RENESAS TECHNICAL UPDATE

Product Category	MPU/MCU		Document No.	TN-H8*-A417A/E	Rev.	1.00
Title	The addition of TNP-64B package to H8/38004 and H8/38002S Group		Information Category	Technical Notification		
Applicable Product	H8/38004 H8/38002S	Lot No.	Reference Document	H8/3802,H8/38004,H8/38002S,H8/38104 Group Hardware Manual (REJ09B0024-0600)		
		All

We would like to inform you of addition of TNP-64B package to H8/38004 and H8/38002S Group.

Hardware Manual (Referring to Section 1.1, Features, page 3)

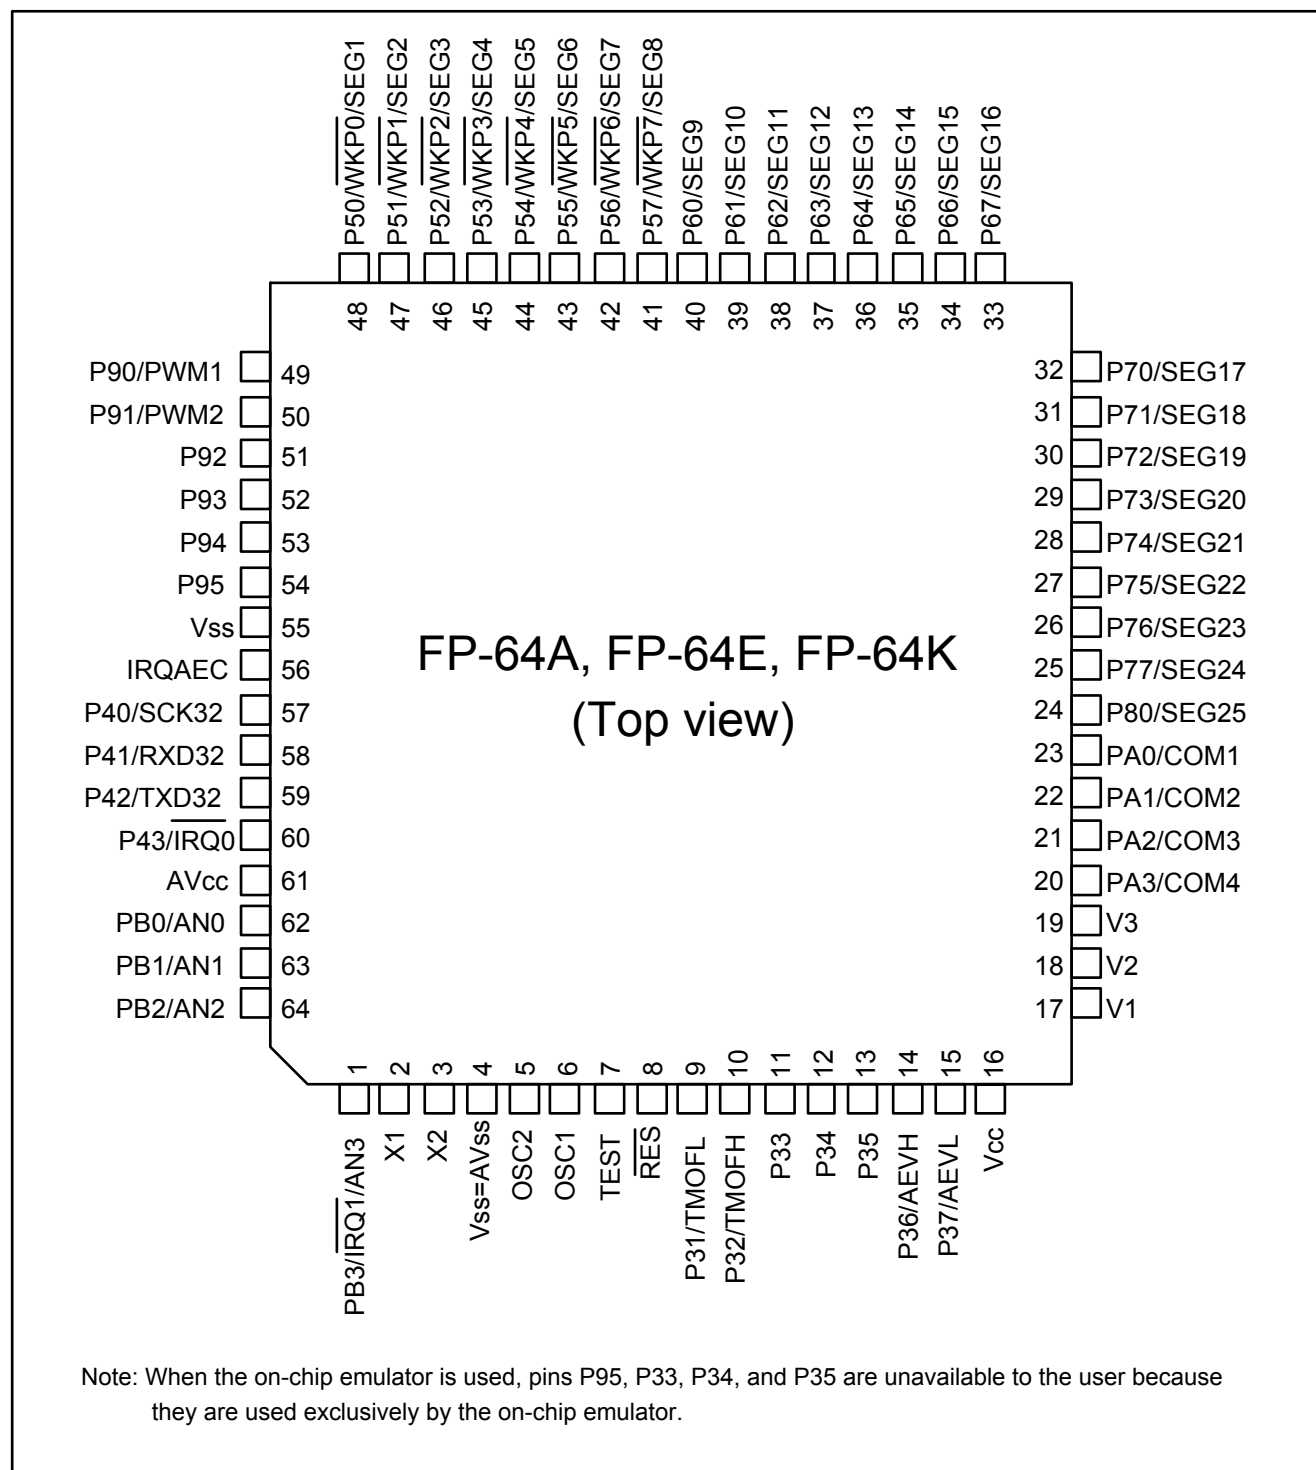
• After Changes

Package	Code	Body Size	Pin Pitch
QFP-64	FP-64A	14.0 x 14.0 mm	0.8mm
LQFP-64	FP-64E	10.0 x 10.0 mm	0.5mm
LQFP-64	FP-64K	10.0 x 10.0 mm	0.5mm
P-VQFN-64	TNP-64B	8.0 x 8.0 mm	0.4mm
DP-64S	DP-64S	17.0 x 57.6 mm	1.0mm
Die	-	-	-

Hardware Manual (Referring to Section 1.3, Pin Arrangement, page 7)

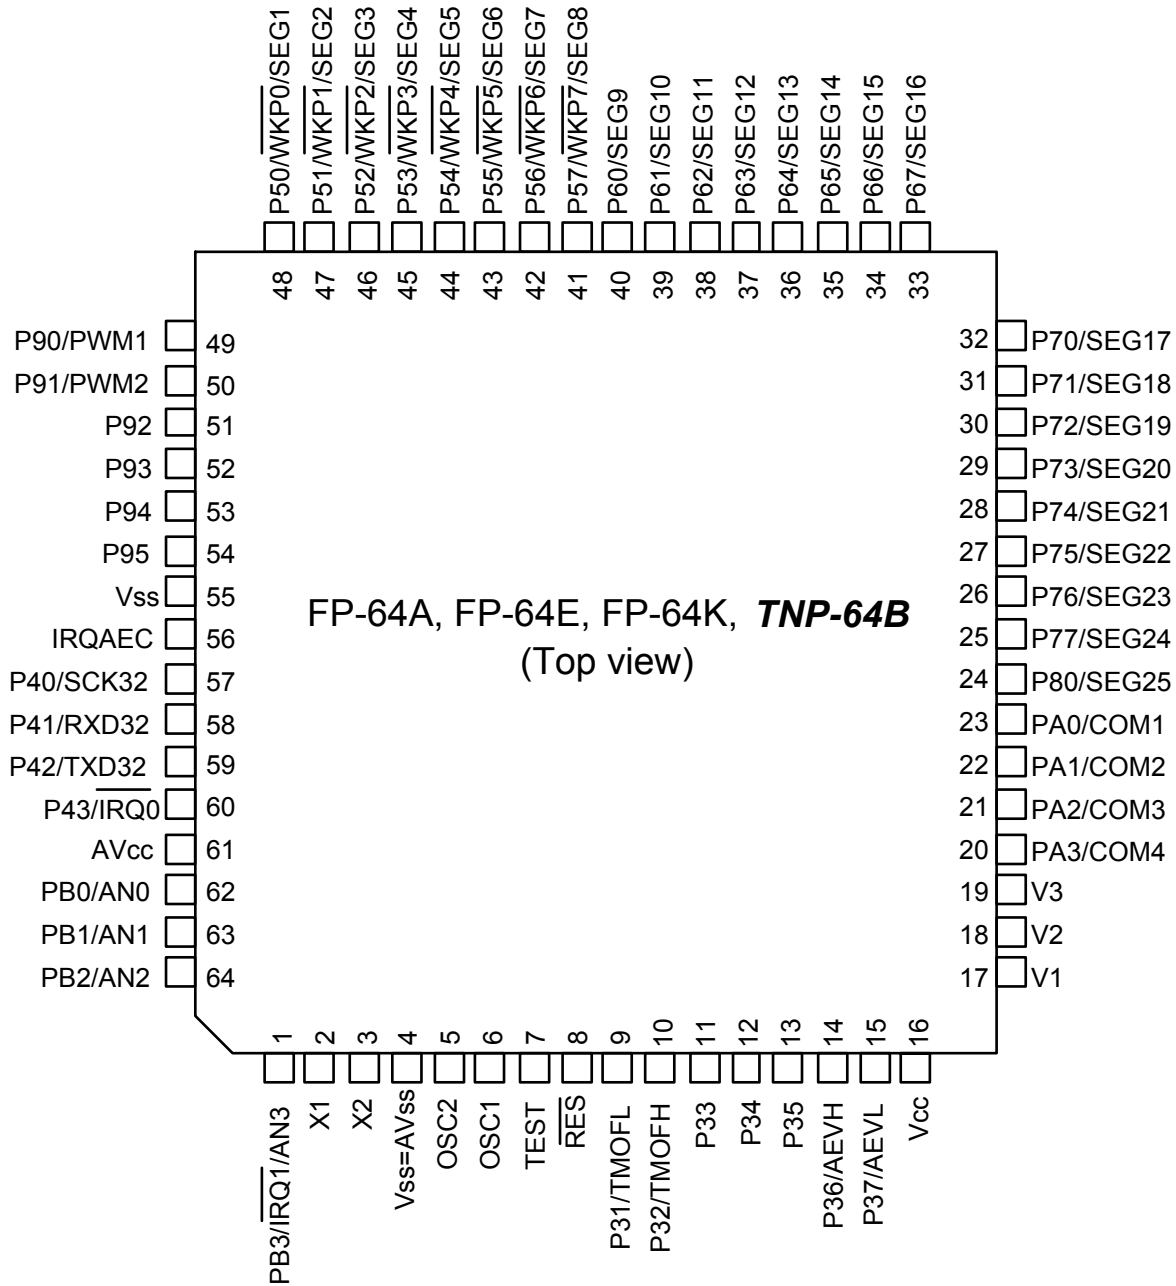
- Before Changes

- After Changes

Hardware Manual (Referring to Section 6.10.1, Socket Adapter, Figure 6.12(1), page 162)

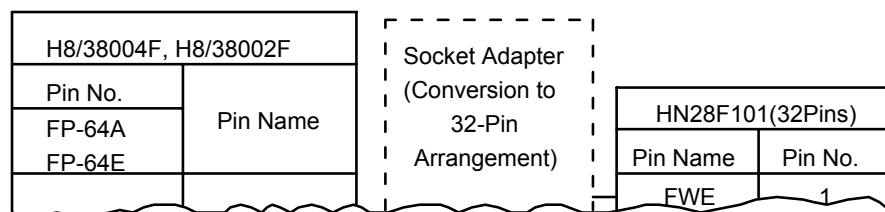
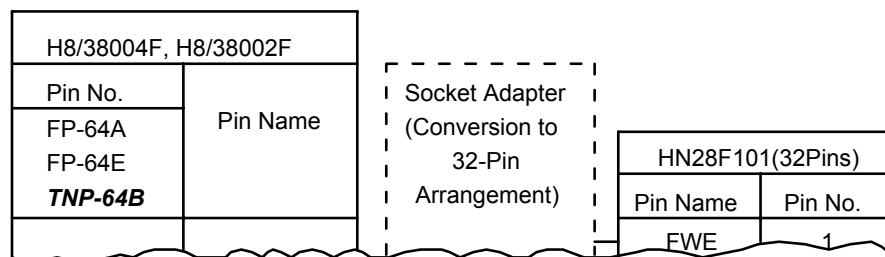
- Before Changes

- After Changes

Hardware Manual (Referring to Appendix E, Package Dimensions, page 490)

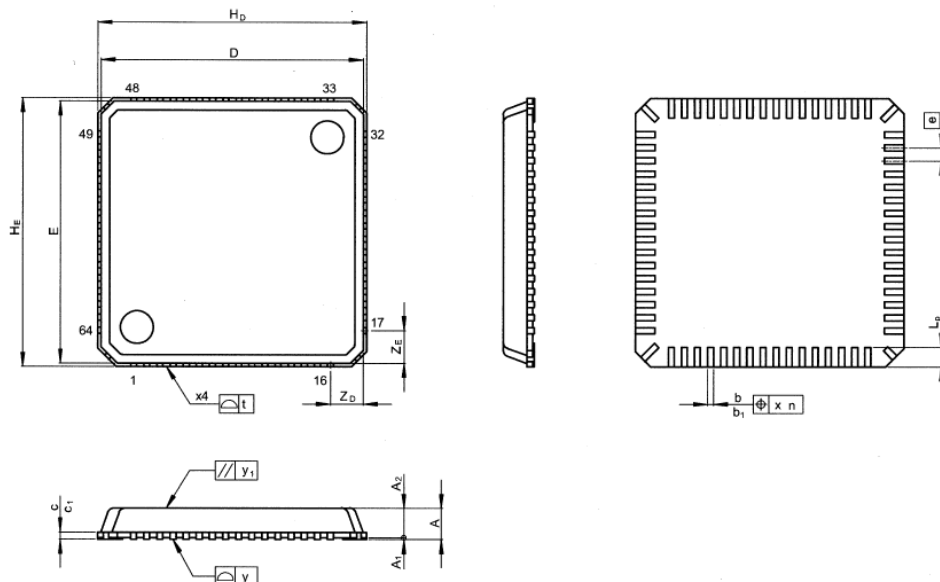
JEITA Package Code	RENESAS Code	Previous Code	MASS[Typ.]
P-VQFN64-8x8-0.40	PVQN0064LB-A	TNP-64B/TNP-64BV	0.12g
